PLANNING AND ZONING BOARD AGENDA MONDAY, JULY 15, 2024 6:30 PM - CITY HALL AUDITORIUM

Application No. / Project Title: 24-33 / City of Tarpon Springs
Ordinance: Draft Ordinance #2024-04
Staff: Patricia L. McNeese, AICP
Planning Supervisor
Applicant / Owner: Habitat for Humanity of Pinellas, Inc.
Property Size: 0.310 acres (13,500 square feet)
Current Land Use: Residential Medium (RM)
Current Zoning: Residential Multifamily (RM)
Proposed Zoning: R-60 (One and Two Family Residential)
Location / Parcel ID: 433 E. Harrison St. / Parcel ID: 13-27-15-64962-001-0080

#23-156 – Site Plan Approval – Luggers Backup, LLC Resolution #2024-23

PAVING DETAIL
N.T.S.

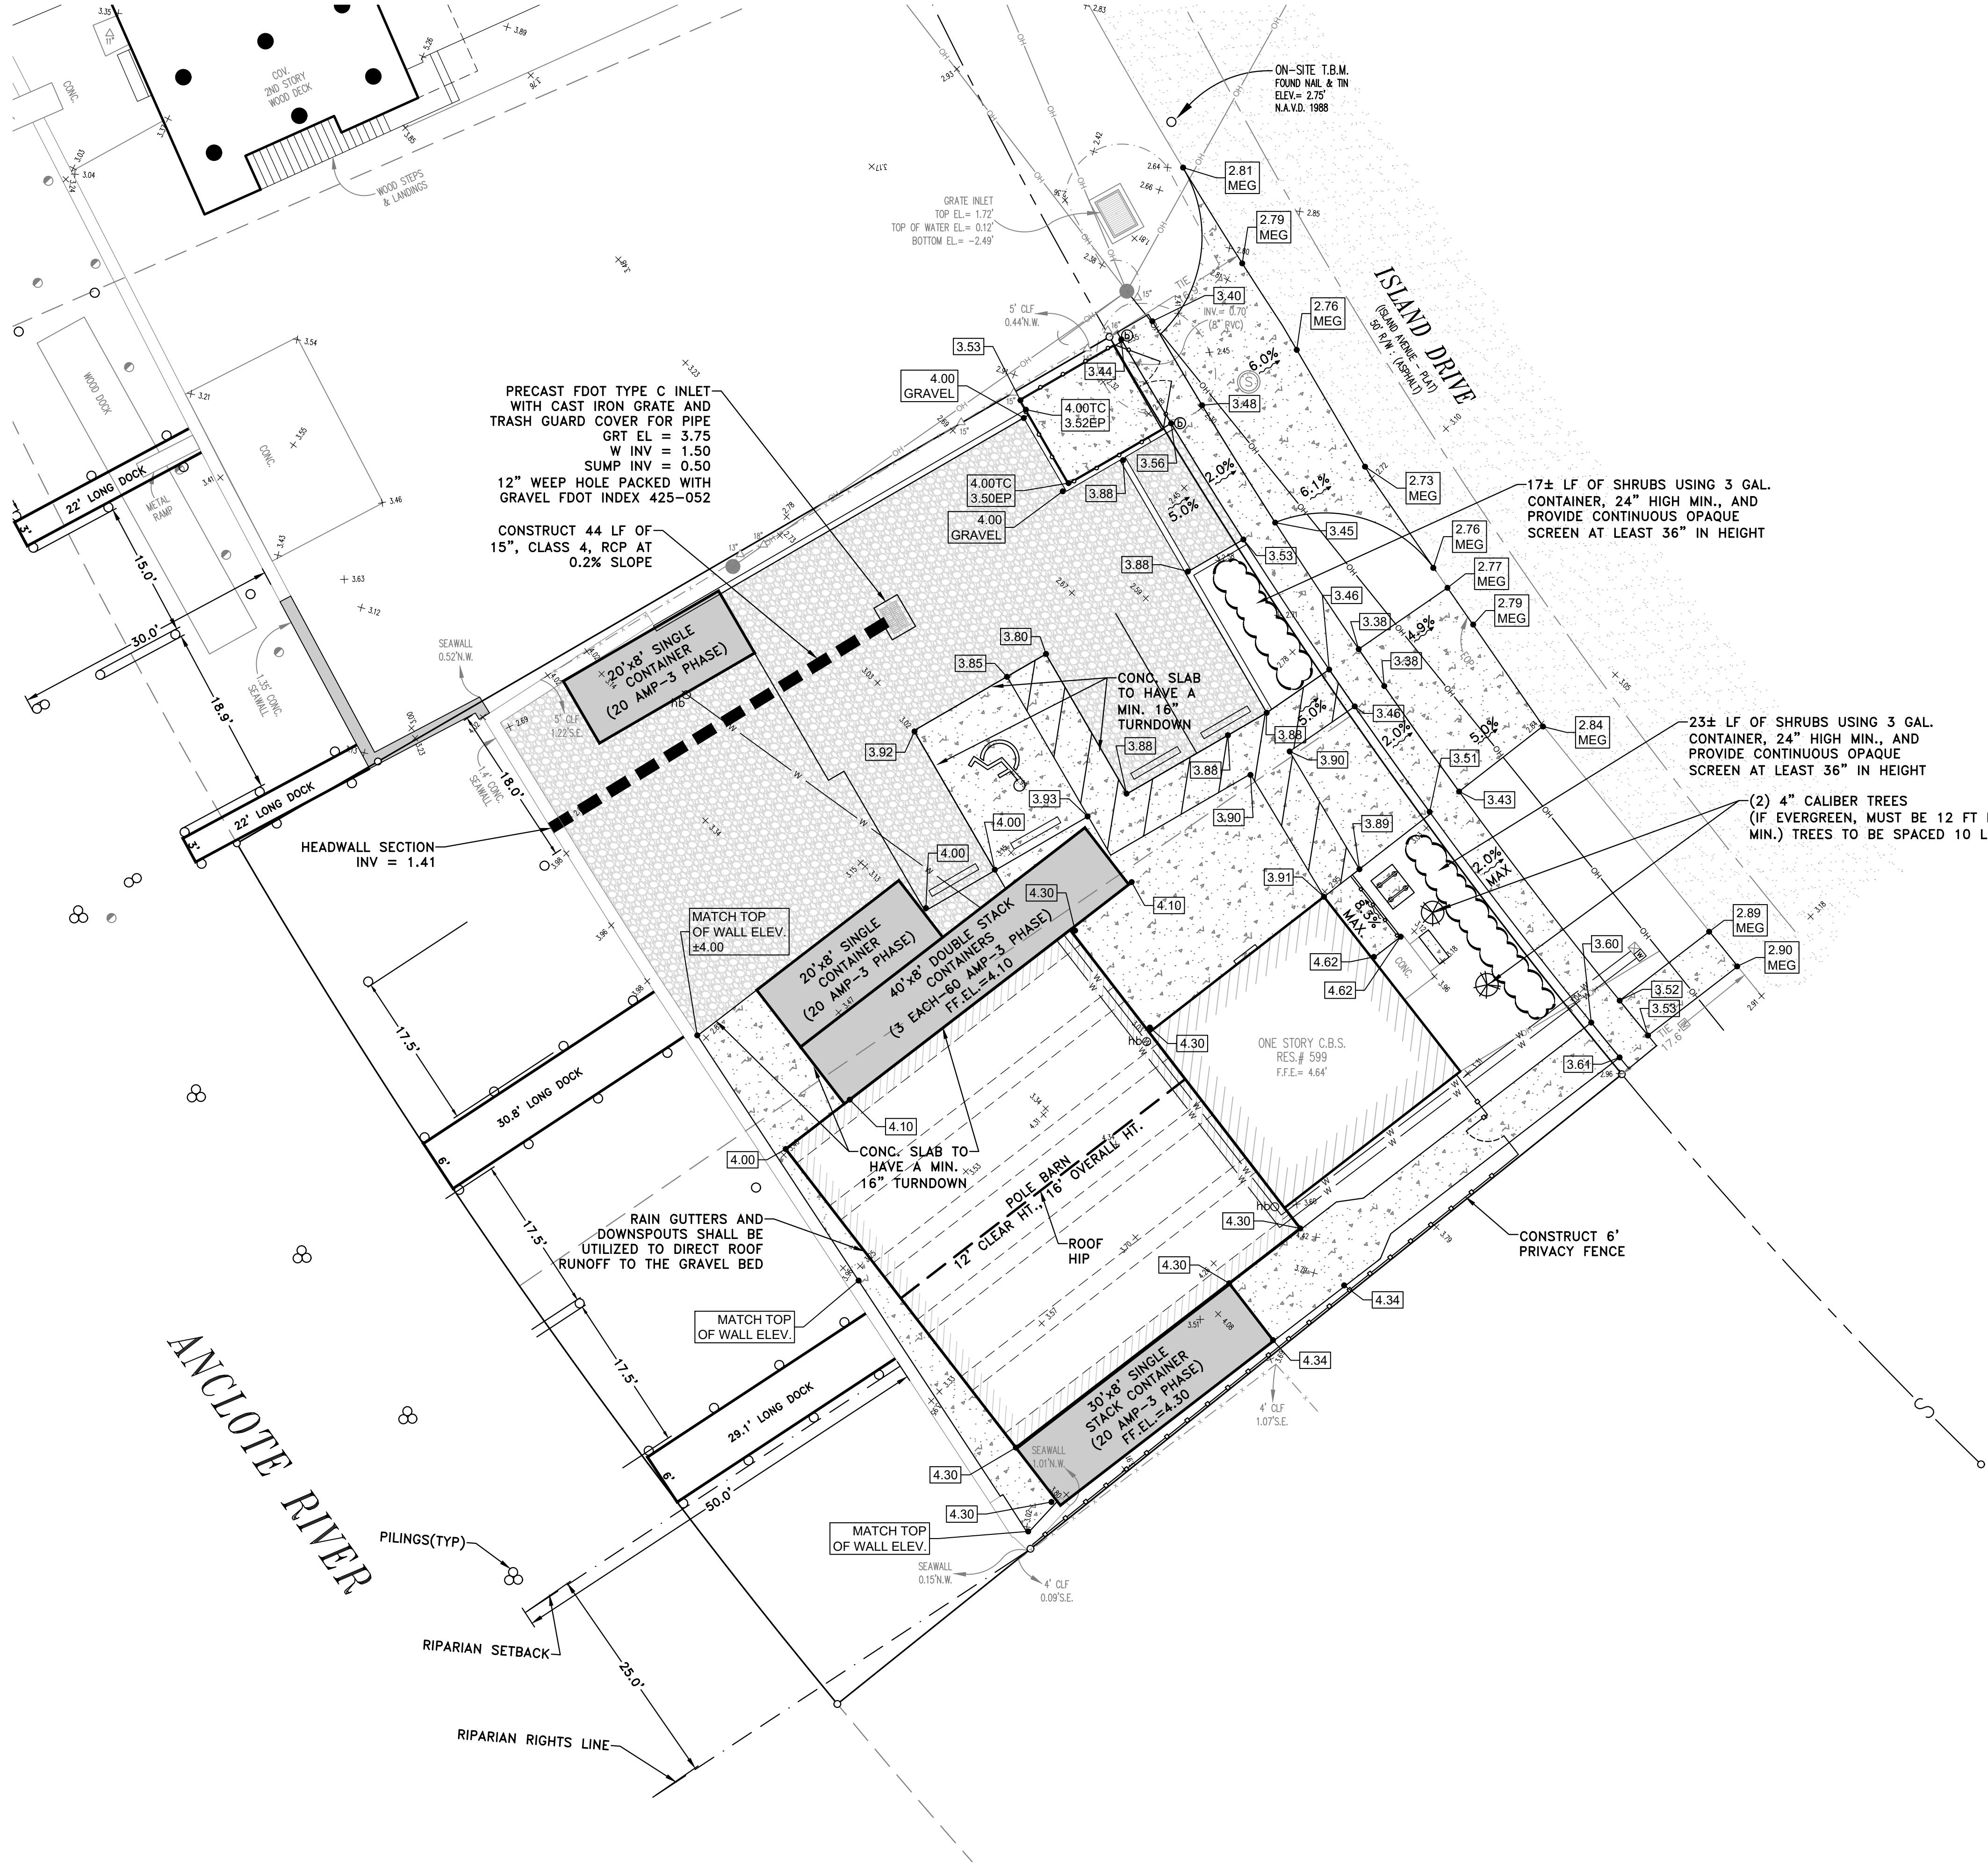
The crushed stone area is subject to vehicular use, and the proposed grate inlet and outfall pipe on plan sheet 4 have the potential to directly discharge sediments to the Anclote River. Downstream of the inlet, provide an additional drainage manhole structure, which incorporates a sediment sump, baffle, and an oil/grease skimmer.

The proposed grate inlet and outfall pipe on plan sheet 4 have the potential to directly discharge sediments to the Anclote River. Consider incorporating a baffle in the structure to ensure solids are trapped, or provide details for "trash guard cover" referenced in structure call out.

It appears that the #57 stone on plan sheet 4 is intended to be used as dry retention storage? Note that the area is subject to vehicular use and wheel loads could cause compaction of the in situ soils beneath the stone. Provide drainage calculations demonstrating sufficient water quality volume and recovery. Provide reasonable assurance that the stone will be maintained to prevent clogging with fines over time. Consider incorporating a bmp that uses cells as structural support.

1. The Site Data table on the plans shall be updated to reflect the correct property acreage.
2. A Utility Availability Statement (UAS) shall be completed.
3. The plans shall be revised to show an additional drainage manhole structure which incorporates a sediment sump, baffle, and oil/grease skimmer downstream of the grate inlet, in order to prevent direct discharge of sediments to the Anclote River.
4. A completed Sediment and Erosion Control sheet shall be submitted.
